{In Archive} RE: Responses to EPA Risk Assessment Comments

Subject: Responses to EPA Risk Assessment Comments

## **EPA Appendix F - Risk Assessment # 20**

**Figure 7-1 Stylized Cross-Section of the On-site Cell "**

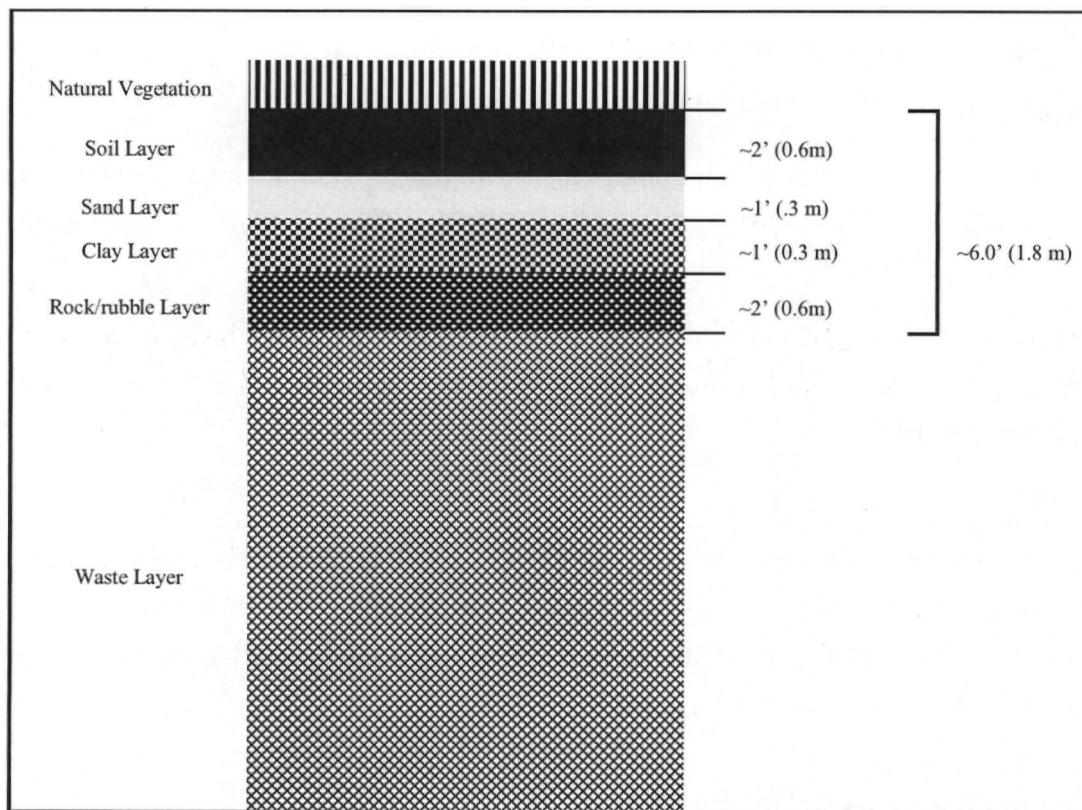
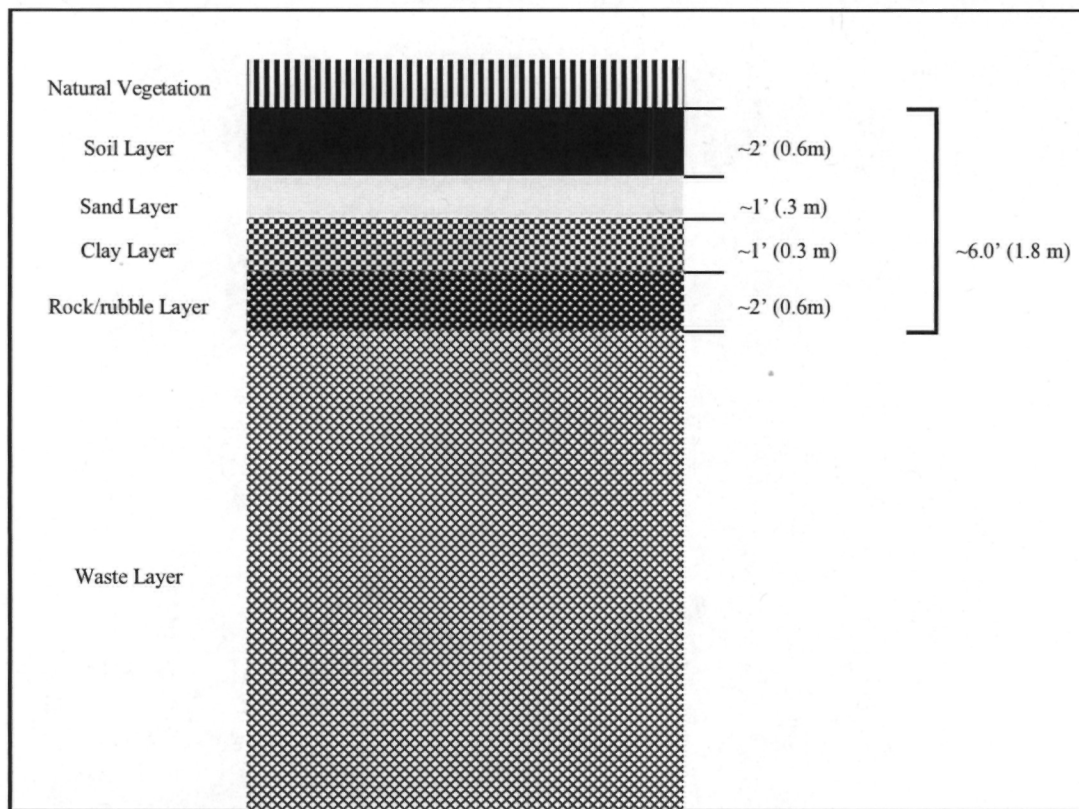
Section 7.2.1: The physical configuration of the on-site cell cap in this section does not exactly match the configuration in the text and on Figure 15, in that the geomembrane is not included here.

In addition, the proposed sand layer represents a plane of weakness which could compromise the cap's integrity over the design life of the cap. Once the cap configuration is agreed upon, this risk assessment may need to be revised.

Section 5.3.1, third bullet: The "rock and clay layer" described here appears to be referred to as the "biointrusion layer" in Figure 5-1. These names should be made consistent. This inconsistency also occurs in Section 7.2.1 and Figure 7-1.

The geomembrane was intentionally excluded from Figure 7-1. The effectiveness of the synthetic geomembrane over the 1,000 years was uncertain and only natural components of the cover design were included in the evaluation. The text has been changed to include the rationale for the geomembrane's exclusion.

Figure 7-1 depicts a stylized cross-section of the on-site engineered disposal cell's cover. A geomembrane is included in the engineered cover design, but it is not reproduced in this conceptual cross-section. The longevity of this membrane is uncertain and the membrane was not considered during the calculation of long-term risks. The conceptual models of the RIM below cleanup levels in Areas 1 and 2 after removal of RIM are identical to those presented in Section 6.2.1.

Agreed. All cross-sections in the risk assessment and the corresponding text have been revised.

**Figure 6-1 Stylized Cross-Section after RIM Has Been Excavated  
and Sent for Off-site Disposal "**

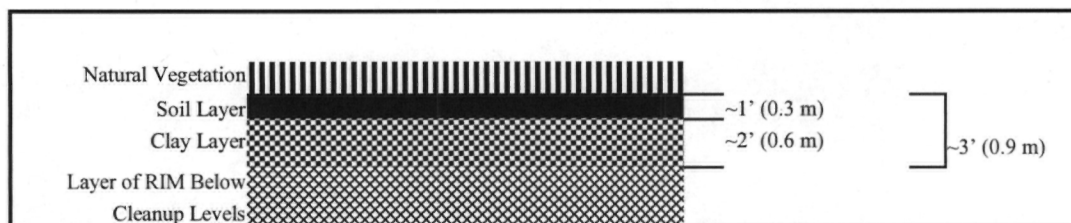
Section 6.2.1, third bullet: The rock layer described in this bullet is missing from Figure 6-1. The text and figure must be reconciled.

The text was has been changed to match the figure.

The text in Section 6.2.1 and Figure 6-1 has been reconciled and now reads:
